Service Bulletin

Date	Ref. No.	Model	TD
30.05.97	IP00997	CM-DX1000	
Subject			IRIS
Standby Time Abnormally Short			1117

SYMPTOM

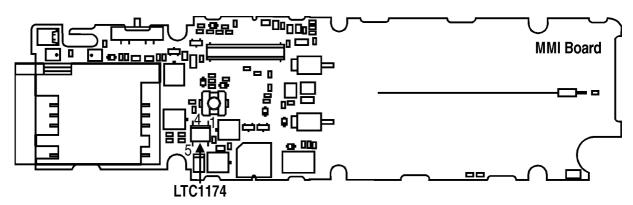
The standby time is abnormally short so that the impression may arise that the battery is defective, or the battery is never totally charged.

Defective IC LTC1147 on the MMI Board.

Replace IC LTC1147 (8-759-336-22). The part is accessible on the MMI Board after removing the Lower Case Shell and the RF Unit.

- Either make a dummy battery or connect the battery terminal of the CM-DX1000 to the power supply.
- Supply 8V.
- · Remove the SIM card and power on.
- Check the current using a milliamperemeter. The current should toggle with a sequence of about 1 ~ 2 seconds between detection mode and idle mode.
- During the detection mode period the current should be 40 ~ 220 mA.
- During the idle mode period the current should be 9 ~ 16 mA. A higher value indicates that the LTC1147 IC is defective.

Using a voltmeter, measure the voltage between GND and pin 4 or 5 of IC LTC1174 while the unit is powered on. The voltage should range between 1.24 \sim 1.28V. A voltage of >1.3V indicates that the LTC1147 IC is defective.
